City of Fayetteville Staff Review Form

ADM 19-6808: Administrative Item (417 W. MLK BLVD./FARMERS CO-OP APTS., 523-562): Submitted by CEI ENGINEERING, INC. for property located at 417 W. MLK BLVD. The properties is zoned MSC, MAIN STREET CENTER and contains approximately 18 square feet. The request is for a reduction to the Master Street Plan Right-of-Way.

SUBJECT: **ADM 19-6808: Administrative Item (417 W. MLK BLVD./FARMERS CO-OP APTS., 523-562):** Submitted by CEI ENGINEERING, INC. for properties located at 417 W. MLK BLVD. The property is zoned MSC, MAIN STREET CENTER and contains approximately 18 square feet. The request is for a reduction to the Master Street Plan Right-of-Way.

SUBJECT: **LSD 19-6681: Large Scale Development (417 W. MLK BLVD./FARMERS CO-OP, 523-562):** Submitted by CEI ENGINEERING, INC. for properties located at 417 W. MLK BLVD. The properties are zoned MSC, MAIN STREET CENTER & DG, DOWNTOWN GENERAL and contain approximately 6.62 acres. The request is for a mixed-use development with 35,469 square-feet of commercial space and 220 dwelling units with associated parking.

EXHIBIT 'A'

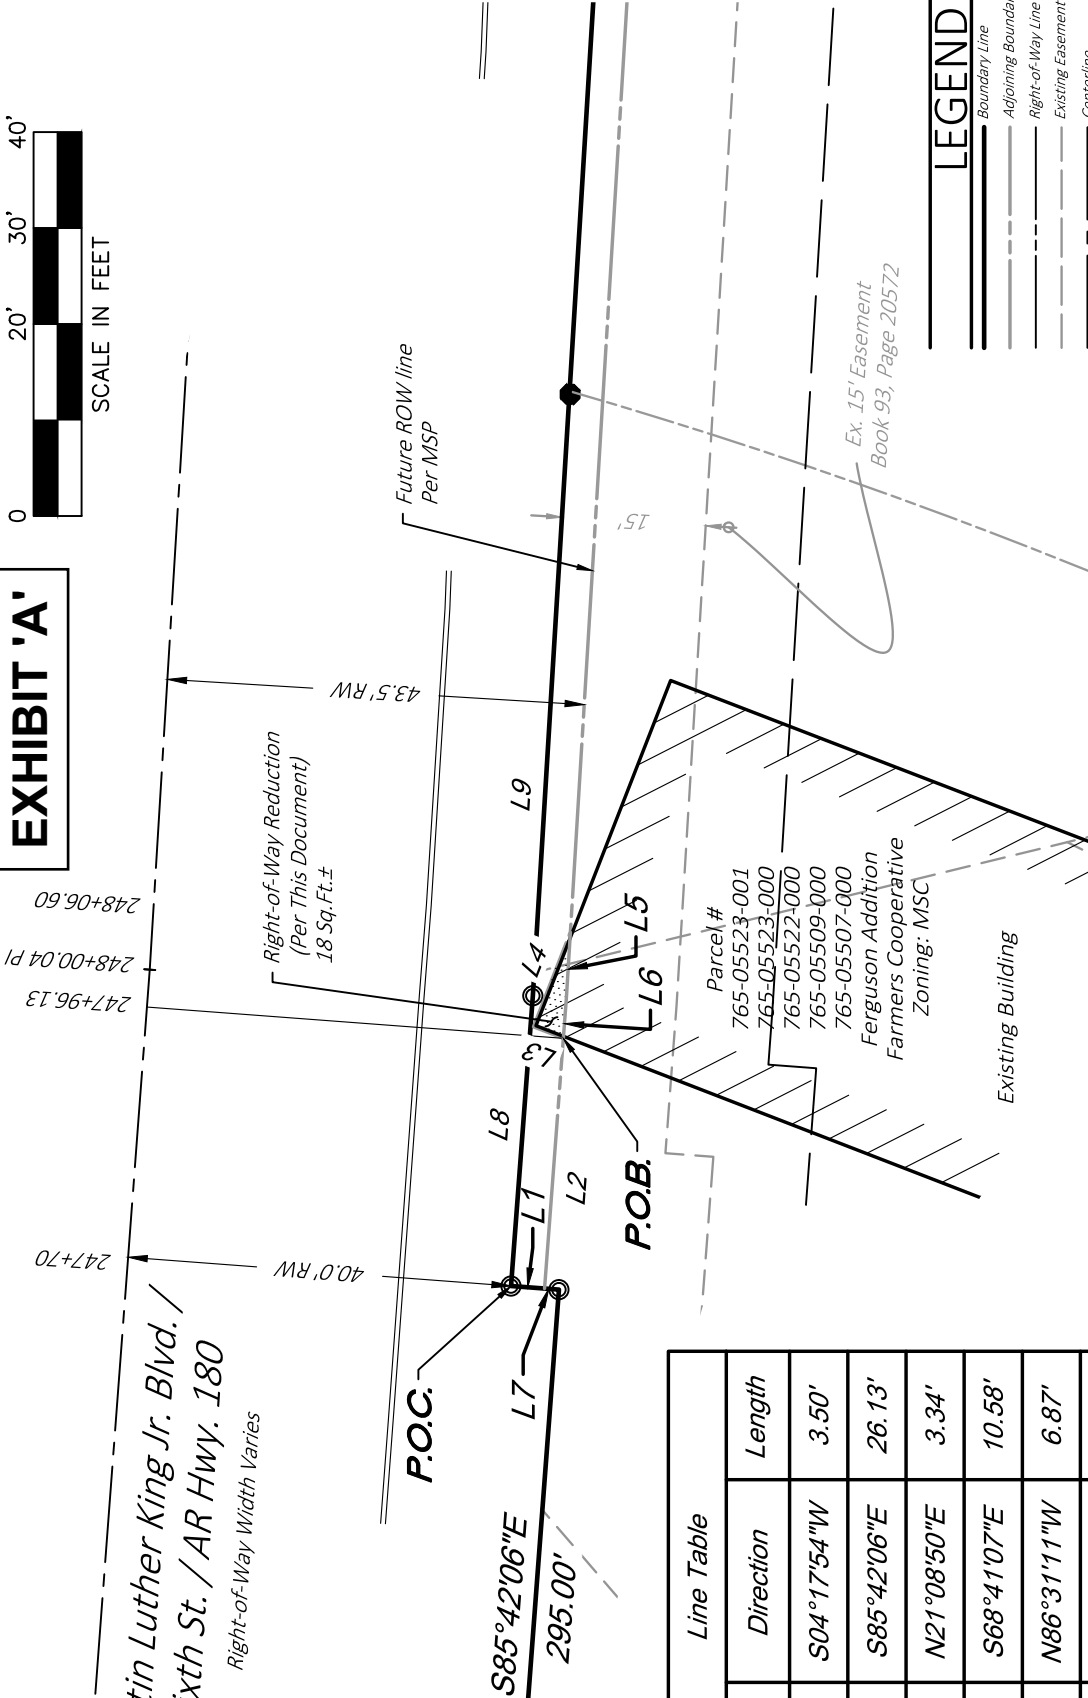
Planning Commission and staff recommend approval of a request to accept a lesser right-of-way dedication as depicted in Exhibits 'A' and 'B' with the following conditions:

1. The requested lesser right-of-way dedication is limited to the area occupied by the structure and within the Master Street Plan right-of-way, totaling 18-square feet, as denoted by the applicant in Exhibit 'A'.

Trail Realignment Exhibit

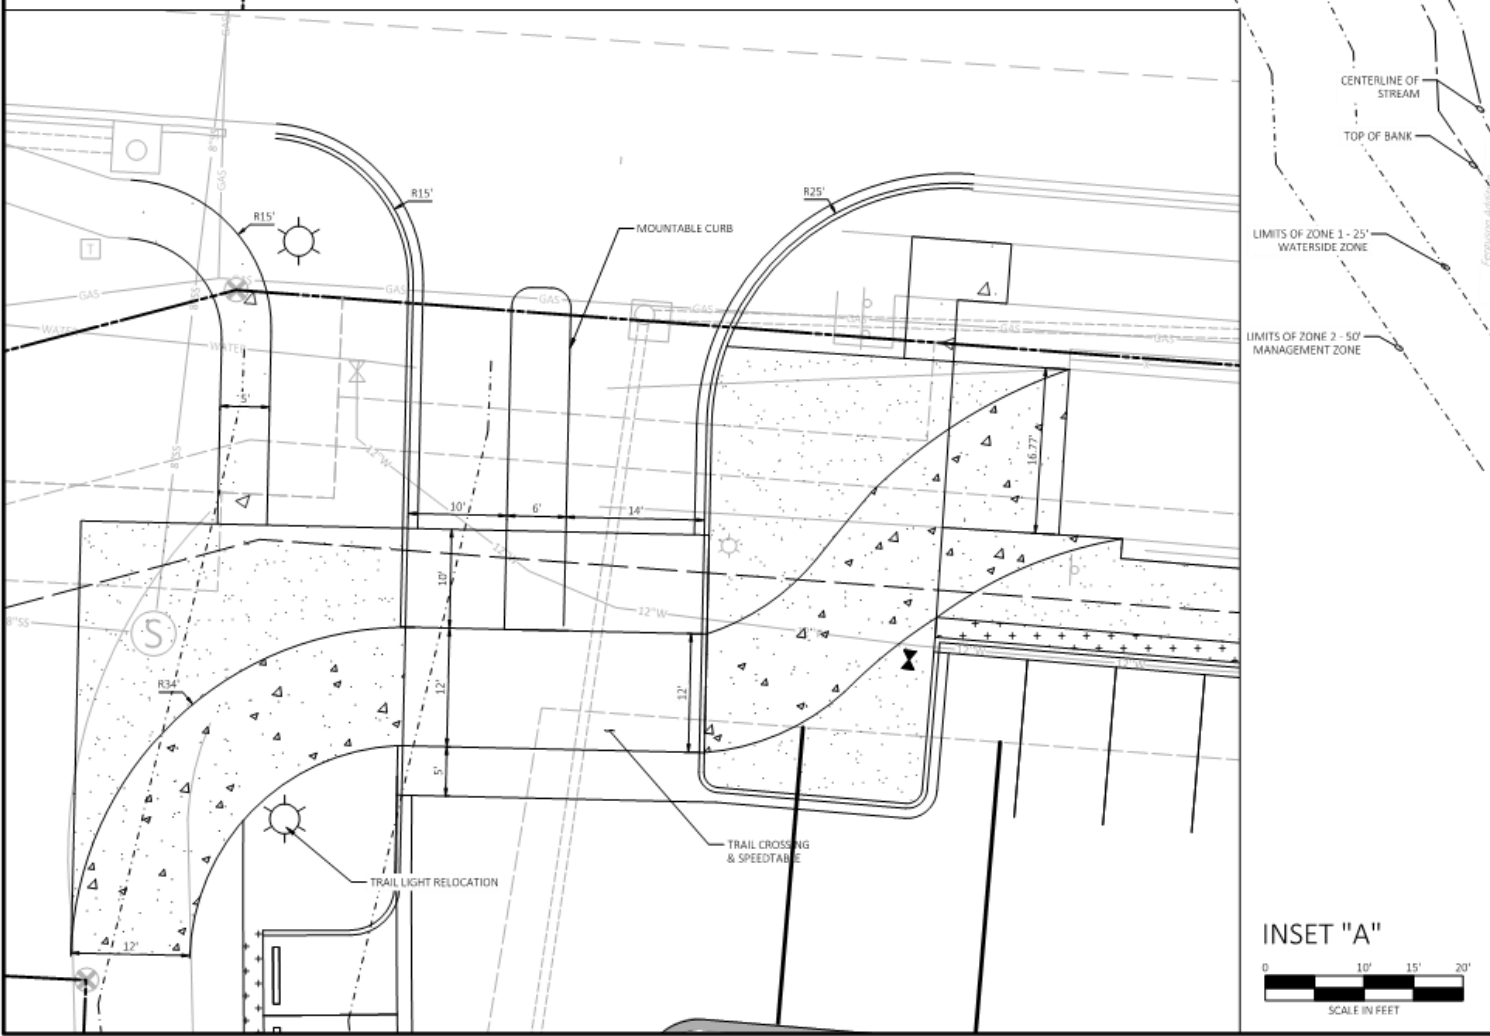
2. Easement Exhibit:
 - a. Show the proposed utility configuration on the easement exhibit.
3. Raised Trail Crossing, Prior to Construction Permitting:
 - a. Further coordination will need to occur between staff, ARDOT, and the applicant regarding sign types and locations for the trail crossing at the northwest corner of the site.

- b. Provide final details for trail crossing signage.
 - c. Applicant has submitted plans to ARDOT for review, and is to coordinate any final changes with staff pending comments from ARDOT pertaining to configuration.

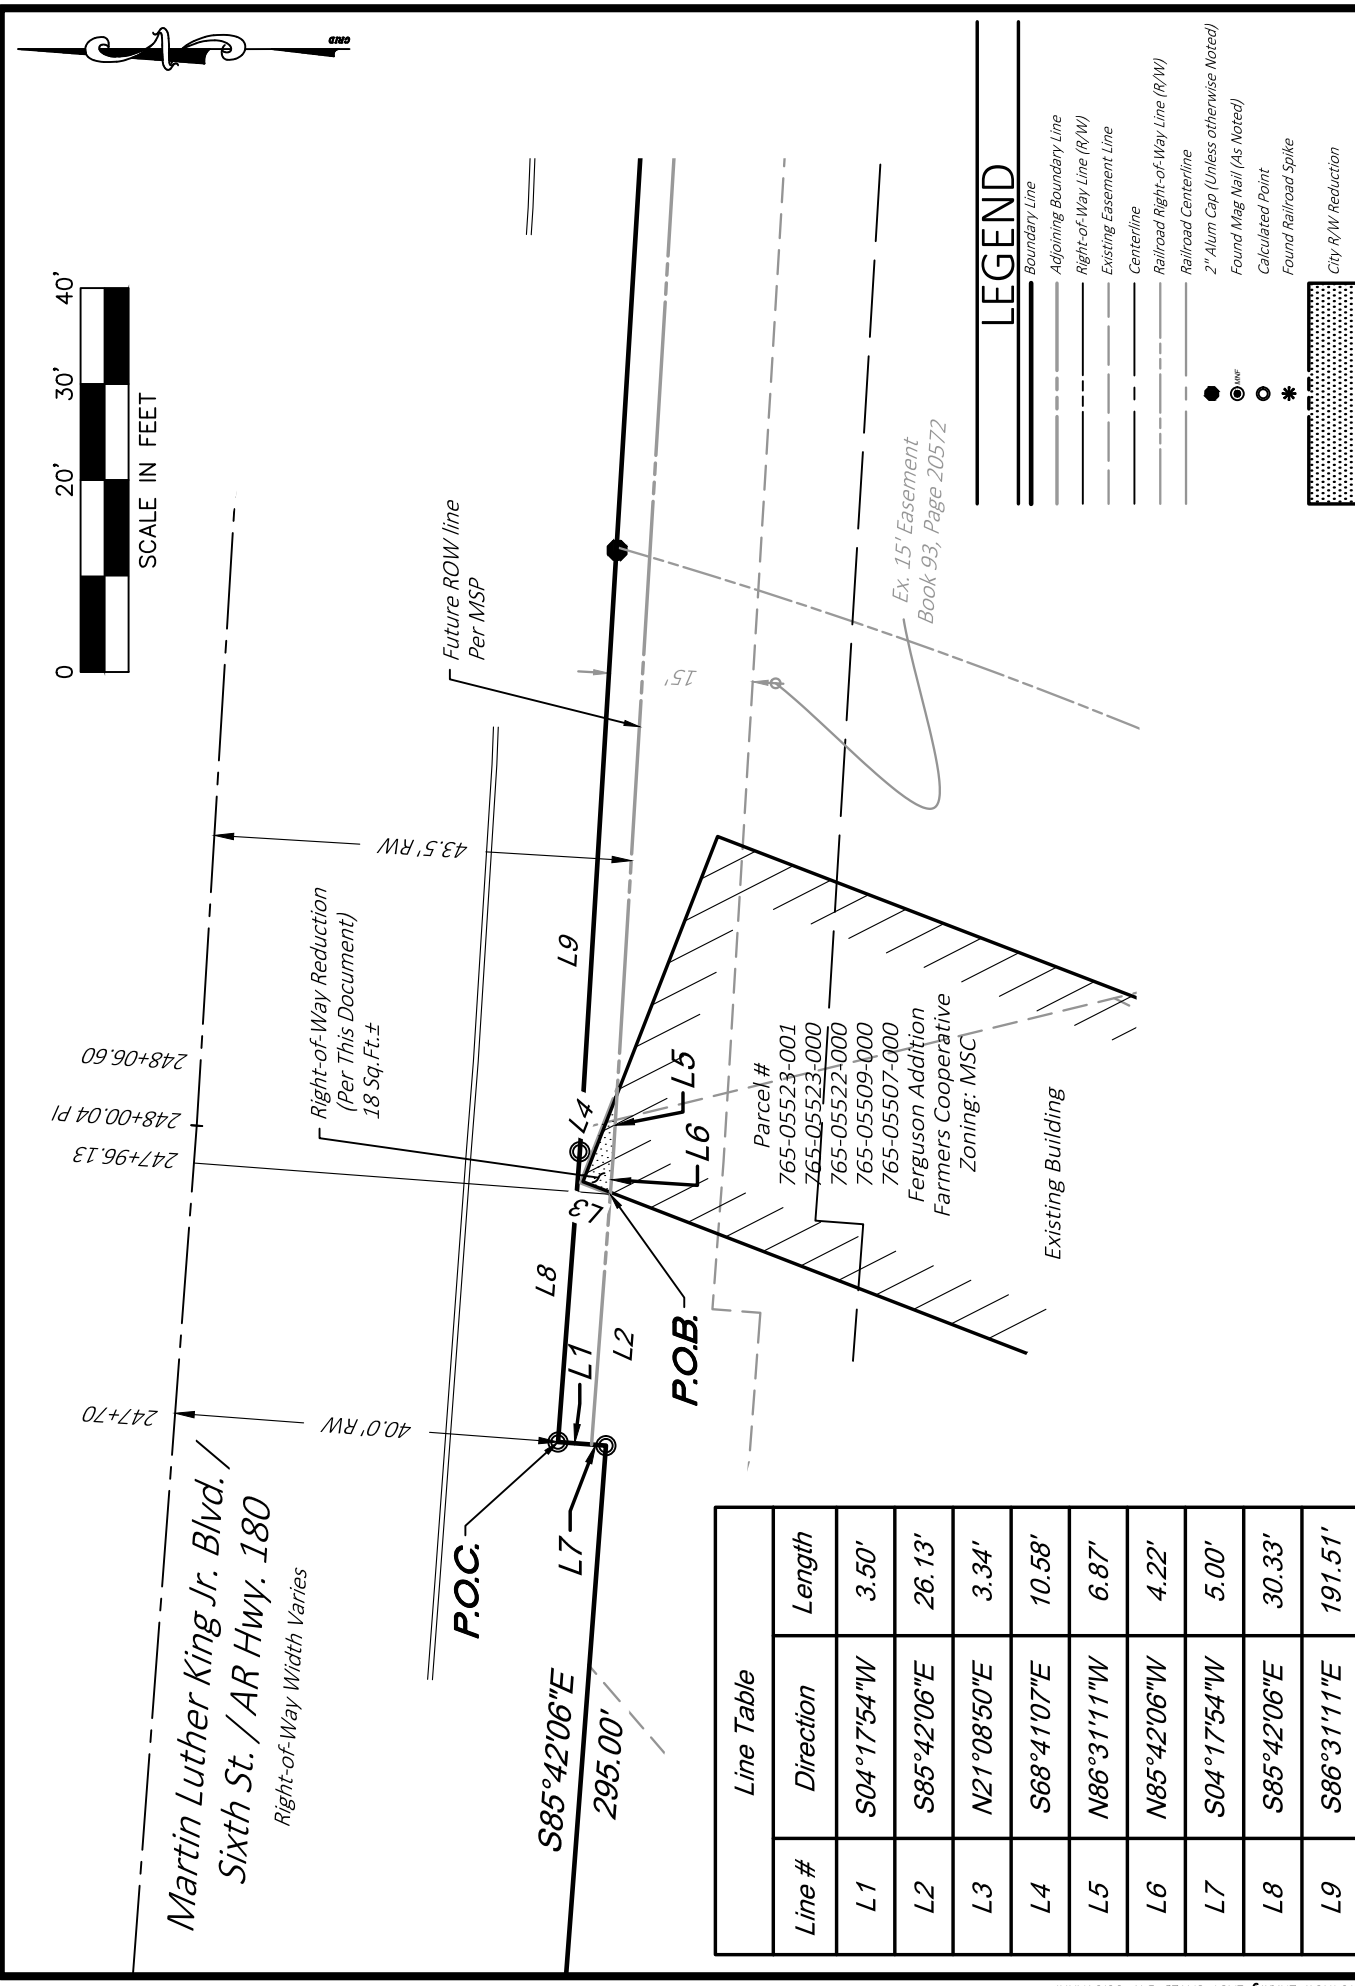
The northwest corner of the existing structure is located at the current edge of right-of-way. The additional dedication cannot reasonably be accommodated without signification modification to the existing structure. The building would encroach 3.34 feet into the proposed right-of-way dedication. The intent of this request is to allow the structure to remain in its current position and exclude the corner of the building from the dedication. The area to be excluded from the dedication is approximately 18 square feet.

Please refer to the attached exhibit which demonstrates the area in question. We believe the project is most true to its original character by preserving the fabric and shape of the existing building. Thank you in advance for your consideration of this request. We look forward to discussing any questions you may have. Contact me at your convenience in the office at 479-273-9472, or by email: revitts@ceieng.com for further discussion as needed.
